**UNITED STATES ENVIRONMENTAL PROTECTION AGENCY
REGION 10**

Re: EPA Review of the Draft Environmental Impact Statement for the Upper Lochsa Land Exchange (EPA Project #:08-068-AFS)

**EPA Region 10 Detailed Comments on the
Draft Environmental Impact Statement
for the Upper Lochsa Land Exchange
2/22/2011**

Attachment 1 – EPA Comments on Upper Lochsa Land Exchange DEIS

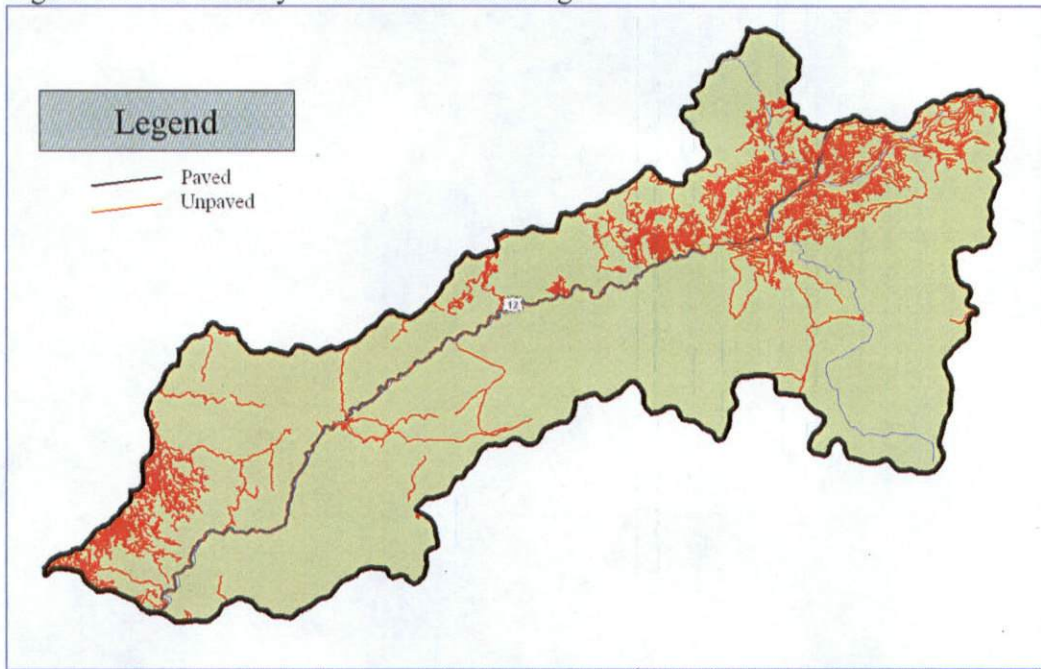
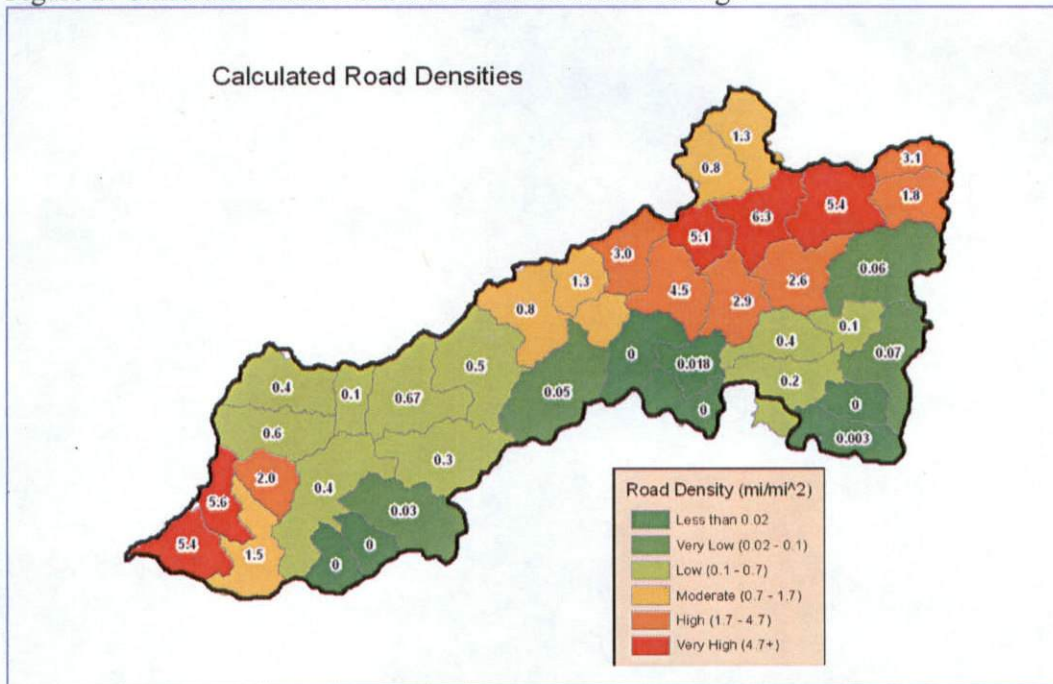
importance of not only the ongoing restoration work in the basin, but the potential water quality benefits afforded by the proposed land exchange. Attachment 1 provides a graphical representation of road densities in the upper Lochsa basin. Managing the upper basin as a whole toward meeting Forest Plan standards for road density and stream conditions will be critical to moving the water bodies within the basin toward fully supporting beneficial uses. We encourage the Forest Service to continue to prioritize restoration efforts within the Lochsa drainage. We also encourage the Forest Service to include the \$500,000 commitment on the part of WPT as a term of the exchange in the Record of Decision.
